November 24, 2014

**RE: Comments on the Revised Draft Environmental Impact Report for the Phillips 66 Company Rail Spur Extension and Crude Unloading Project**

Union Pacific Crude-By-Rail Lines.

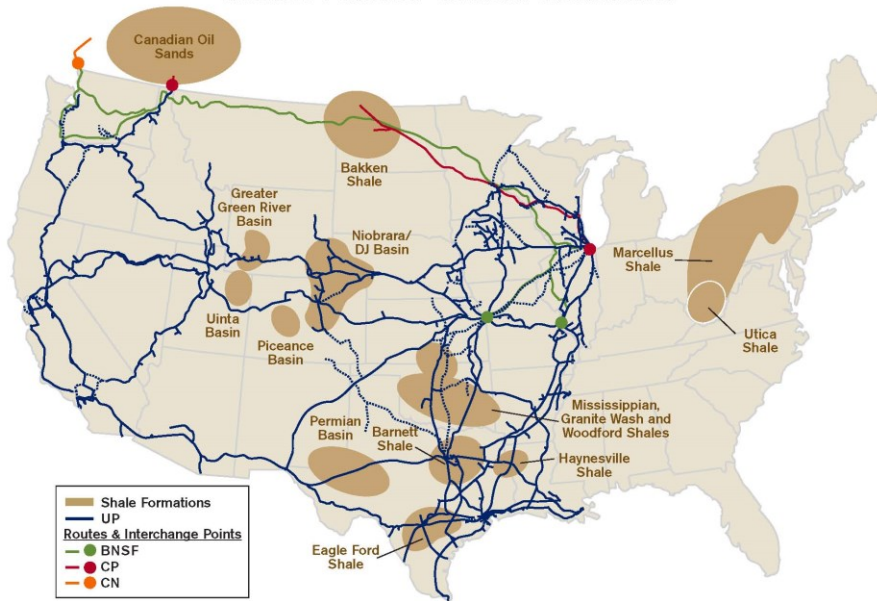
The RDEIR limits its analysis of the impacts from a crude oil spill along the UPRR mainline to the section of track between the Roseville and Colton rail yards. However, CEQA requires an EIR to discuss the significant impacts that the proposed project will have in the relevant geographic area.<sup>233</sup> Agencies must “provide a reasonable explanation for the geographic limitation used,”<sup>234</sup> and the geographic scope “cannot be so narrowly defined that it necessarily eliminates a portion of the affected environmental setting.”<sup>235</sup>
